<b>Subject:</b> <b>OIL LEAK FROM COMPANION FLANGE AREA OF TRANSFER UNIT</b>	<b>Bulletin No.:</b> 03-003/18
	<b>Last Issued:</b> 09/20/2018

2013-2016 CX-5 AWD vehicles with VINs lower than JM3KE\*\*\*\*\*878977 (produced before October 5, 2016)

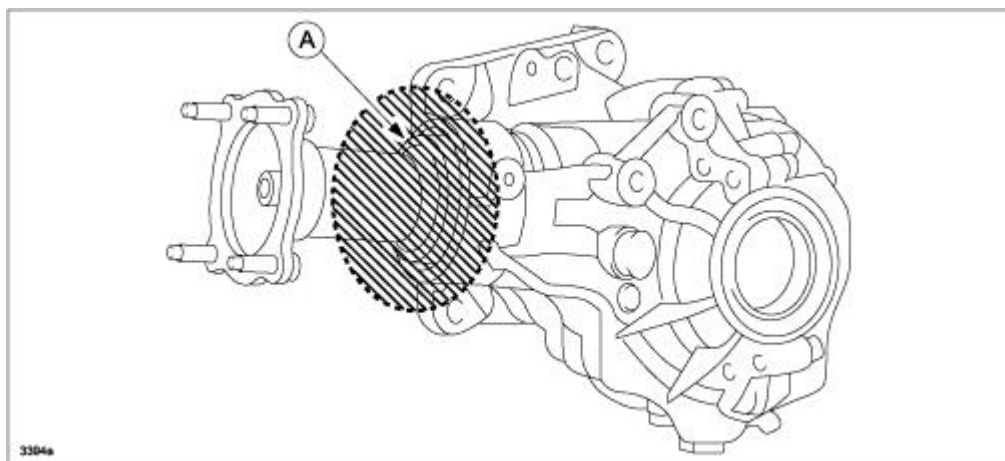
Some vehicles may exhibit an oil leak from the companion flange area (A) of the transfer unit. This concern may be caused by companion flange oil seal wear. The oil seal has been improved to increase the wear resistance.

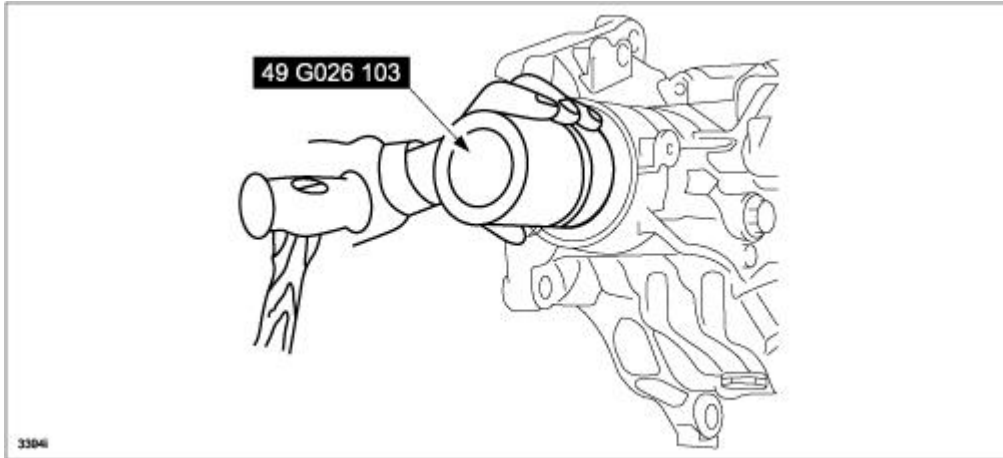
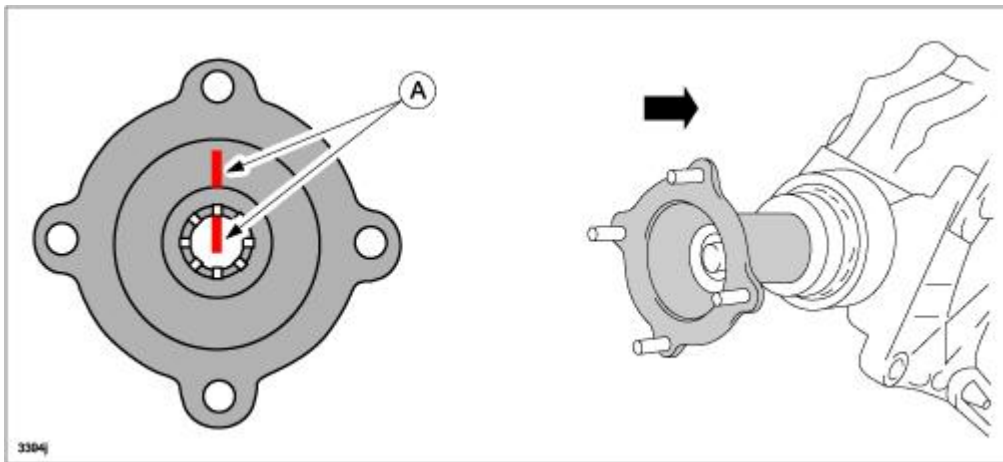
12. Install the modified oil seal using the SST.

**NOTE:** Place the B stamped side of the SST onto the oil seal side.
